# UNITED STATES PATENT AND TRADEMARK OFFICE

APPLICATION NO.	FILING DATE	FIRST NAMED INVENTOR	ATTORNEY DOCKET NO.	CONFIRMATION NO.
10/790,923	03/01/2004	Nancy C. Frye	063293.0110	1435
5073	7590	10/28/2005	EXAMINER	
BAKER BOTTS L.L.P.			PATTERSON, MARIE D	
2001 ROSS AVENUE			ART UNIT	
SUITE 600			PAPER NUMBER	
DALLAS, TX 75201-2980			3728

## Office Action Summary

FIG. 14

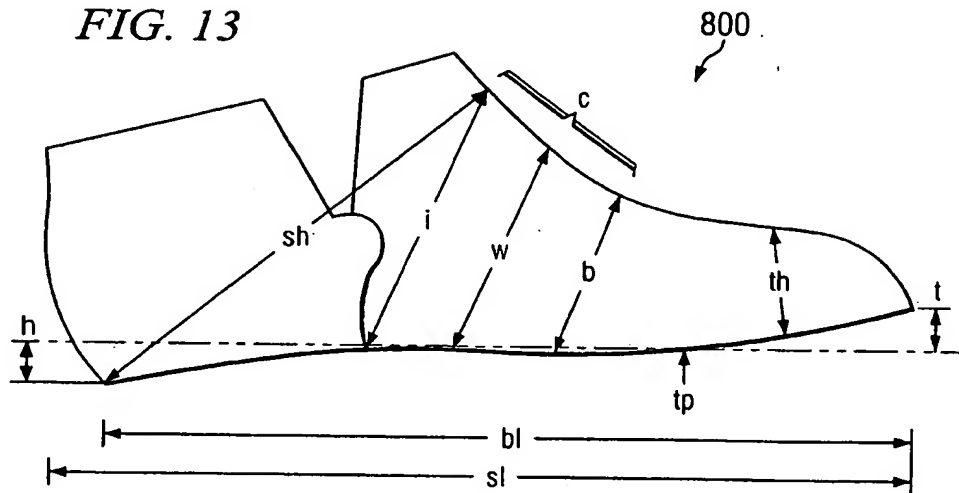
3. The drawings were received on 10/26/05. These drawings are not entered because they contain new matter, i.e. the thickness, shape, exact location, etc. of the midsole is considered to be new matter. In response applicants' arguments directed towards the new matter added to the drawings in order to show the midsole, it is noted that it is applicants' responsibility when originally filing the application to ensure that all claimed elements are clearly shown in the drawings, the addition of elements at a later date in most cases does add new matter and will not be entered.
4. The drawings are objected to under 37 CFR 1.83(a). The drawings must show every feature of the invention specified in the claims. Therefore, the midsole(s) must be shown or the feature(s) canceled from the claim(s). No new matter should be entered.

5. The drawings are objected to because the specification states that 824 is a point at  $\frac{1}{2}$  the length of the shoe, however the point at 824 in figure 14 appears to be clearly in the forefoot portion of the shoe, this is confusing. Corrected drawing sheets in compliance with 37 CFR 1.121(d) are required in reply to the Office action to avoid abandonment of the application. Any amended replacement drawing sheet should include all of the figures appearing on the immediate prior version of the sheet, even if only one figure is being amended. The figure or figure number of an amended drawing should not be labeled as "amended." If a drawing figure is to be canceled, the appropriate figure must be removed from the replacement sheet, and where necessary, the remaining figures must be renumbered and appropriate changes made to the brief description of the several views of the drawings for consistency. Additional replacement

Do Not Enter  
cmap 10/26/05
